Access Compliance Report Public Rights-of-Way (Curb Ramps)

Intersection ID: 9126
 Main Street:
 REDBUD_ST
 Cross Street:
 PITTS_DR
 Location:
 SW

ADA ID: F9CDCD95A9DE
 Ramp Type:
 Para
 Initial Pass/Fail:
 Fail
 Overall Compliance:
 No
 Severity Score:
 22.5

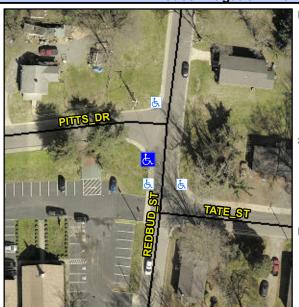
RT RP < 5%

R304.5.1, R304.3.2, R304.5.3

Field Measurements/Component Compliance					
Compliance Description		Data	Comp	Compliance Description	
N/A	Ramp Length LT (in)	66.0	N/A	Ramp Length RT (in)	66.0
No	Ramp Width LT (in)	47.0	Yes	Ramp Width RT (in)	48.0
No	Ramp Slope LT (%)	8.5	Yes	Ramp Slope RT (%)	2.2
No	Ramp XSlope LT (%)	2.6	Yes	Ramp XSlope RT (%)	1.7
N/A	Landing Length (in)	N/A	N/A	DWS Provided?	N/A
N/A	Landing Width (in)	N/A	N/A	DWS Contrast?	N/A
N/A	Landing Slope (%)	N/A	N/A	DWS Length (in)	N/A
N/A	Landing X Slope (%)	N/A	N/A	DWS Full Width?	N/A
N/A	Landing Curb? (Y/N)	N/A	N/A	DWS Offset (in)	N/A
N/A	Shared Landing?	N/A			
N/A	Gutter Ponding?	N/A	N/A	Gutter Slope (%)	N/A
N/A	Gutter Lip Ht (in)	N/A	N/A	Gutter X Slope (%)	N/A
N/A	Painted X Walk1?	No	N/A	Painted X Walk2?	N/A
	X Walk 1 Direction	To N		X Walk 2 Direction	N/A
N/A	X Walk 1 Width (in)	N/A	N/A	X Walk 2 Width (in)	N/A
	X Walk 1 Slope (%)	1.5		X Walk 2 Slope (%)	N/A
	X Walk 1 X Slope (%)	5.9		X Walk 2 X Slope (%)	N/A

Remove & Replace Entire Ramp.
